4.1 Proposed Project (14)

McARTHUR RIVER MINE
OPEN CUT PROJECT
ENVIRONMENTAL IMPACT STATEMENT SUPPLEMENT

LOCATION OF
EXPLOSIVES FACILITIES

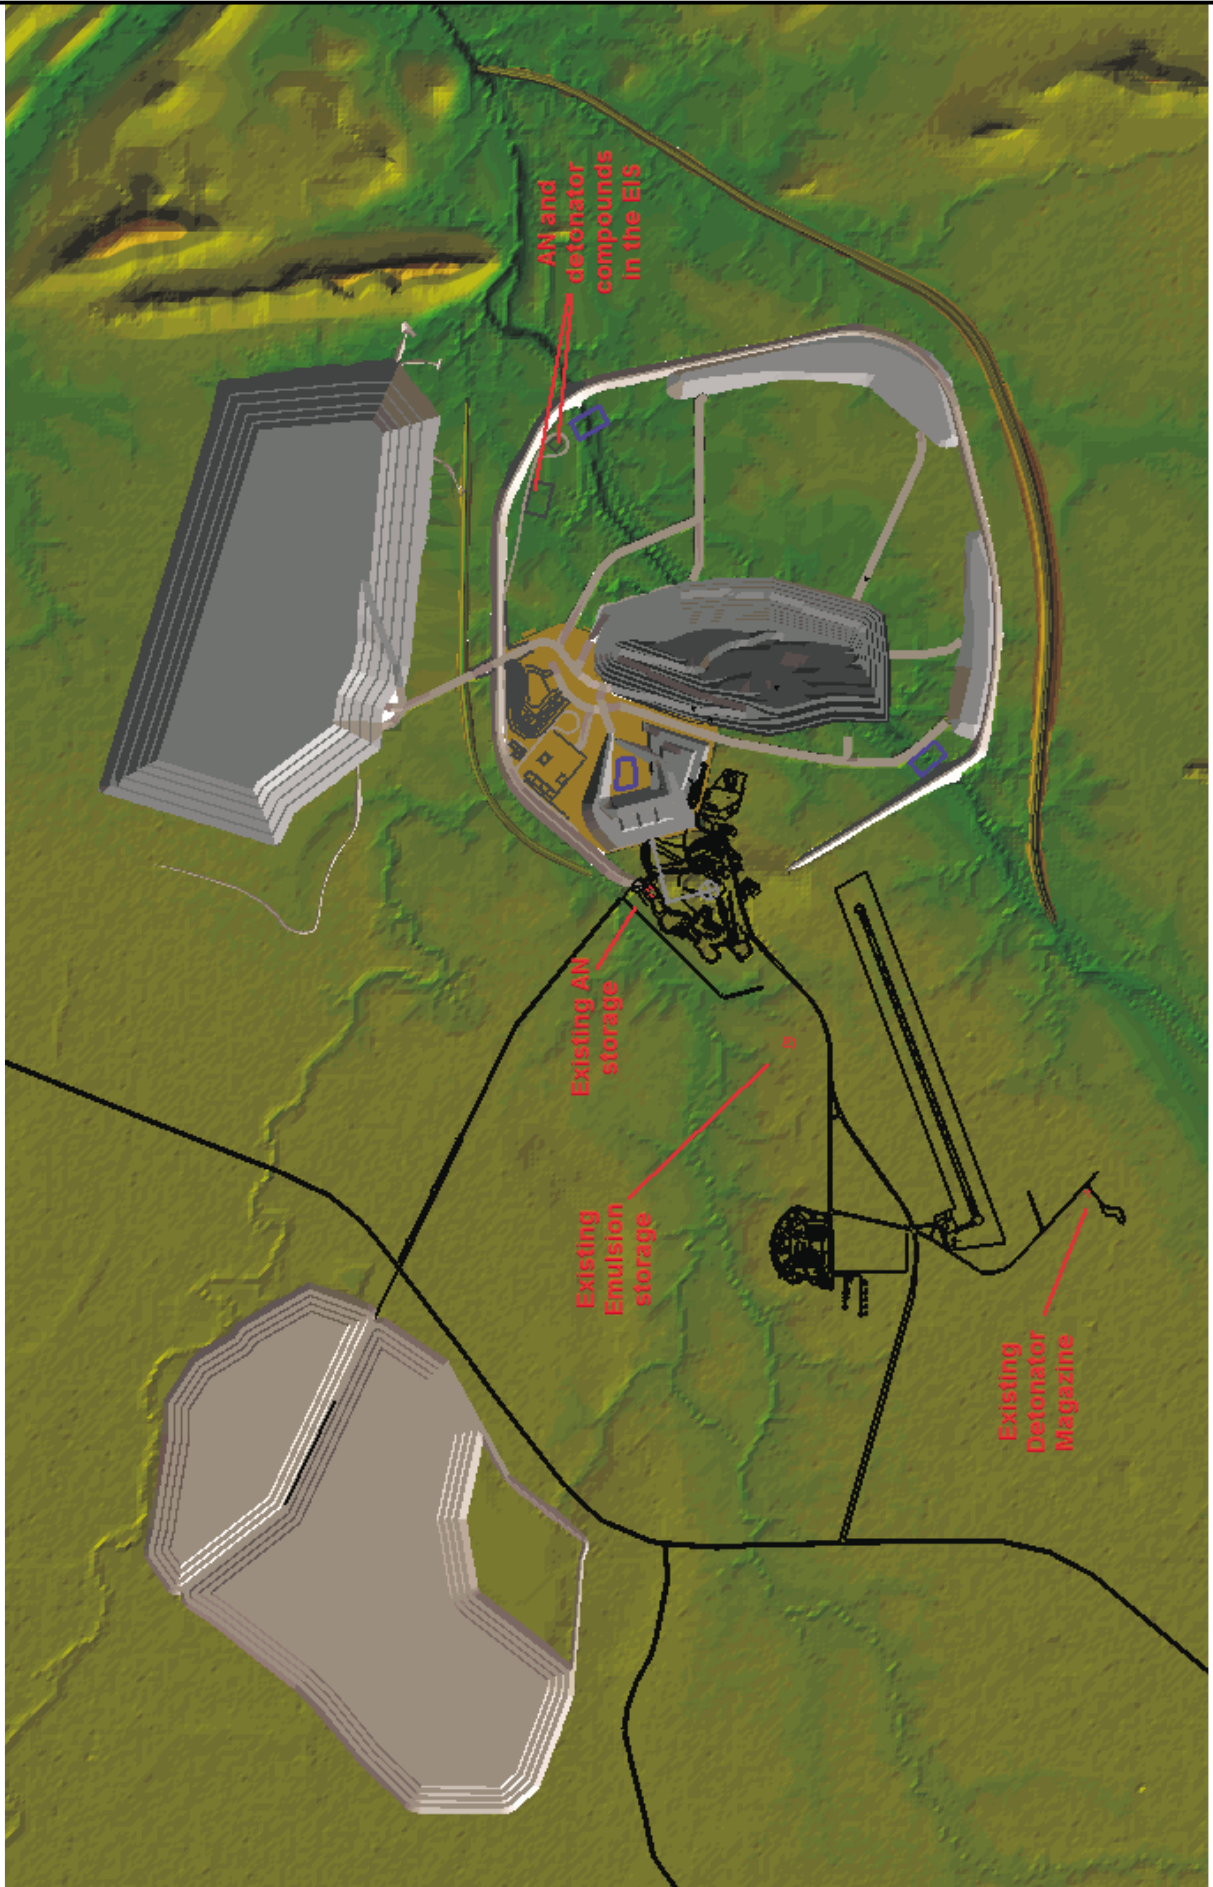
DPIFM has asked for a diagrammatic representation of the explosive storage facilities to assist in assessing the risks associated with the selected location.

The locations for explosives facilities on site are shown in Figure 1.

Figure 1 shows the recently constructed emulsion storage yard and surface magazines that were installed to service the Test Pit. The location of these items was devised to satisfy the following:

- Above the 1:500 year flood level;
- Adequate clearances from surrounding infrastructure and work areas in accordance with the relevant Australian Standards; and
- Safe access for transport vehicles.

Figure 1 also shows the location for the explosives compounds as described in the draft EIS. These are in the north-east portion of the bunded area. The magazines were to be surrounded by suitably sized and constructed earthen walls. This area is well away from any work areas. However, now that alternative locations for the magazines and emulsion storage have been established for the Test Pit, the facilities, as described in the EIS, may remain in their present locations if the open pit operations were to continue rather than be relocated to the location shown in Figure 1.

LAYOUT OF EXISTING
TAILINGS STORAGE FACILITY

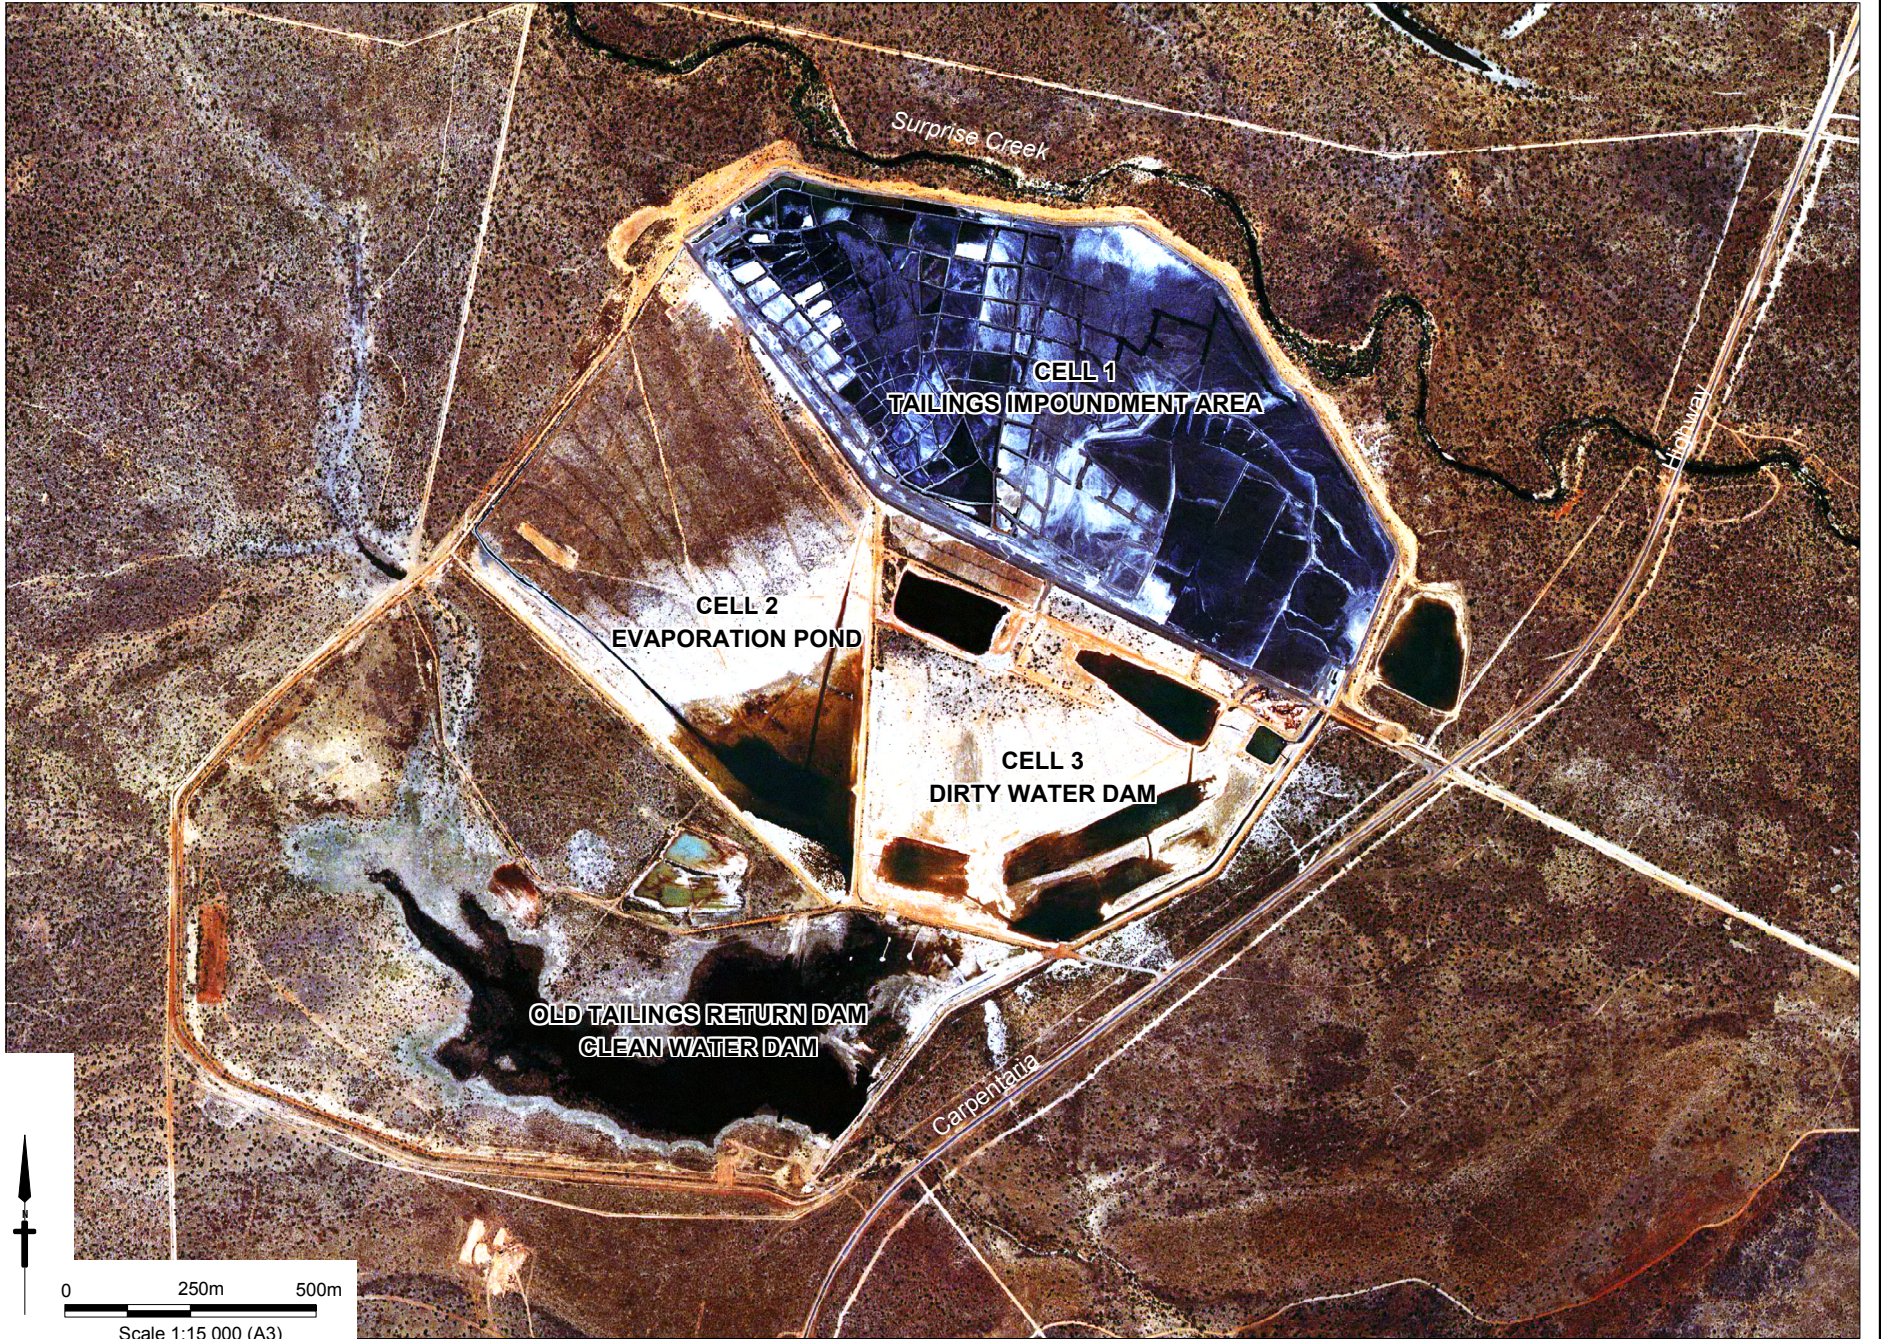
DPIFM noted that Figure 7.7 was not included in the EIS as referenced and would provide useful information on the current structure of the tailings dam.

A copy of Figure 7.7 included on the following page.
